SUBJECT: PUBLIC MEETING SUMMARY ON THE REACTOR OVERSIGHT
PROCESS HELD ON AUGUST 22, 2007

FAQ LOG 08/07

Figure 2.2-1 High Head Safety Injection System

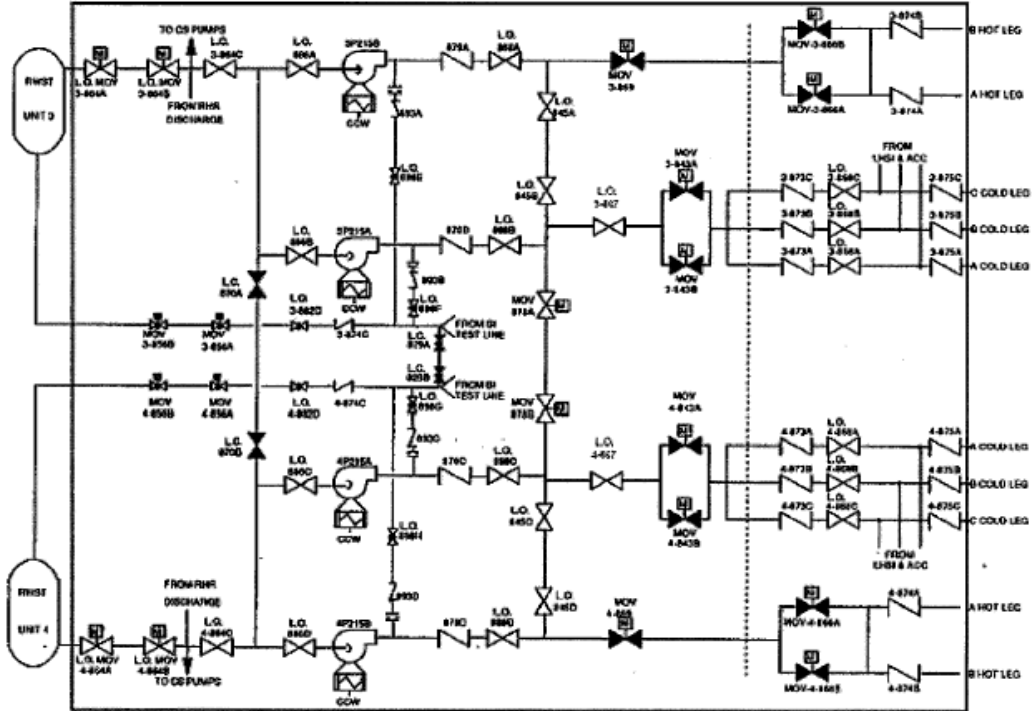
Page F-48, Section F.5, lines 45-46, and page F-49, Section F.5, lines 1-7 of the NEI 99-02, Appendix F guidance describes train determination for three-loop Westinghouse plants; however, the system described therein does not represent the HHSI system at Turkey Point. Therefore, there is no system-specific guidance for HHSI which is applicable to the HHSI system at Turkey Point.

During the week of June 4-8, 2007, an audit of the PTN MSPI programs was conducted. During his review of the PTN MSPI Basis Document proposed update, the technical expert brought in for the audit noted the uniqueness of Turkey Point's HHSI system in that both the Unit 3 and Unit 4 HHSI pumps start on an SI signal from either unit, and all of them feed the stricken unit. He also noted that the generic CCF factors for Turkey Point (NEI 99-02, Table 3) imply that there are 4 pumps being monitored for each unit. The NEI 99-02 guidance for Westinghouse 3-loop plants (pages F-48 and 49), which states that 3-loop plants have 3 pumps, one of which is an installed spare, does not apply for the Turkey Point 3-loop configuration.

For reliability monitoring, the two Unit 3 HHSI pumps are monitored for Unit 3, and the two Unit 4 HHSI pumps are monitored for Unit 4. For unavailability monitoring, the two Unit 3 HHSI pump trains and the two Unit 3 discharge valves are monitored for Unit 3, and similarly, the two Unit 4 HHSI pump trains and two Unit 4 discharge valves are monitored for Unit 4. The opposite-unit pump trains are not monitored for unavailability for either unit. The technical expert for the audit recommended that the opposite-unit HHSI pumps be added for unavailability and reliability monitoring.

At Turkey Point, each unit (Unit 3 and Unit 4) has two HHSI pumps. The Unit 3 and Unit 4 HHSI pumps start on an SI signal from either unit, and all of them feed the stricken unit. Should the Turkey Point reporting model be revised to address the four train approach?

FPL proposes to add the opposite-unit HHSI pump trains for unavailability monitoring for each unit, and the opposite-unit HHSI pumps for reliability monitoring for each unit. Although the opposite-unit HHSI pumps are cooled by the opposite-unit component cooling water (CCW) pumps, it is proposed that they not be added as they are already monitored for their associated unit, and their Birnbaum importances for the opposite-unit are several orders of magnitude less than their Birnbaum importances for their own unit.

Revise NEI 99-02, Appendix D to include the Turkey Point HHSI configuration. The current guidance for three-loop Westinghouse plants in Appendix F does not apply to Turkey Point.

Resolution: Yes. In order to ensure accurate reporting, add the opposite-unit HHSI pump trains for unavailability monitoring for each unit, and the opposite-unit HHSI pumps for reliability monitoring for each unit. Although the opposite-unit HHSI pumps are cooled by the opposite-unit component cooling water (CCW) pumps, they should not be added as they are already monitored for their associated unit, and their Birnbaum importances for the opposite-unit are several orders of magnitude less than their Birnbaum importances for their own unit.
